Access Compliance Report

Public Rights-of-Way

(Curb Ramps)

Intersection ID: 27145	Main Street: SHEPHERDLEAS_LN	Cross Street: WILLESDEN_LN	Location: NW
ADA ID: 52FD7DCEB482	Ramp Type: PerpDiag	Initial Pass/Fail: Fail	Overall Compliance: No
Severity Score: 33.75			
Codes/Mitigation Info/Possible Solution		Field Measurements/Component Compliance

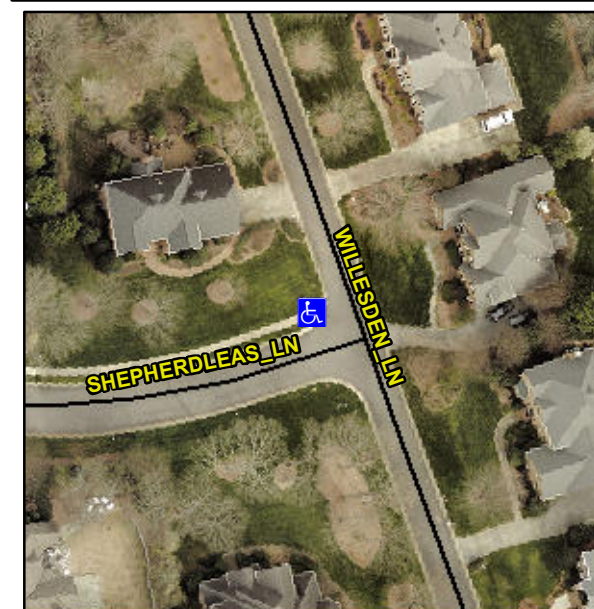
Not Found, R304.5.1, R304.5.3

Compliance	Description	Data	Compliance	Description	Data
N/A	Ramp Length (in)	44.0	Yes	Ramp Slope (%)	6.0
No	Ramp Width (in)	42.5	No	Ramp XSlope (%)	8.5
N/A	Flare Type LT	N/A	N/A	Flare Type RT	N/A
N/A	Flare Slope LT (%)	N/A	N/A	Flare Slope RT (%)	N/A
N/A	Flare Traversable LT?	N/A	N/A	Flare Traversable RT?	N/A
N/A	Landing Length (in)	N/A	N/A	DWS Provided?	N/A
N/A	Landing Width (in)	N/A	N/A	DWS Contrast?	N/A
N/A	Landing Slope (%)	N/A	N/A	DWS Length (in)	N/A
N/A	Landing X Slope (%)	N/A	N/A	DWS Full Width?	N/A
N/A	Landing Curb? (Y/N)	N/A	N/A	DWS Offset (in)	N/A
N/A	Shared Landing?	N/A			
N/A	Gutter Ponding?	N/A	N/A	Gutter Slope (%)	N/A
N/A	Gutter Lip Ht (in)	N/A	N/A	Gutter X Slope (%)	N/A
N/A	Painted X Walk1?	No	N/A	Painted X Walk2?	No
	X Walk 1 Direction	To S		X Walk 2 Direction	To E
N/A	X Walk 1 Width (in)	N/A	N/A	X Walk 2 Width (in)	N/A
	X Walk 1 Slope (%)	8.4		X Walk 2 Slope (%)	0.4
	X Walk 1 X Slope (%)	0.3		X Walk 2 X Slope (%)	7.9

N/A	Ramp inside XWalk1?	N/A	N/A	Ramp inside XWalk2?	N/A
	Road Slope (%)	5.8	N/A	Clear Space?	N/A
	Road X Slope (%)	7.0	N/A	Clear Space to XWalk (in)	N/A
N/A	Any Obstructions?	N/A	N/A	Storm Grate/Utility Hazard?	N/A
	Obstruction Type			Storm Grate/Utility Type	
		N/A			N/A
			Yes	Surface Condition? (G/P)	Good

Remove & Replace Curb Ramp With Two New Directional Ramps or Equivalent.
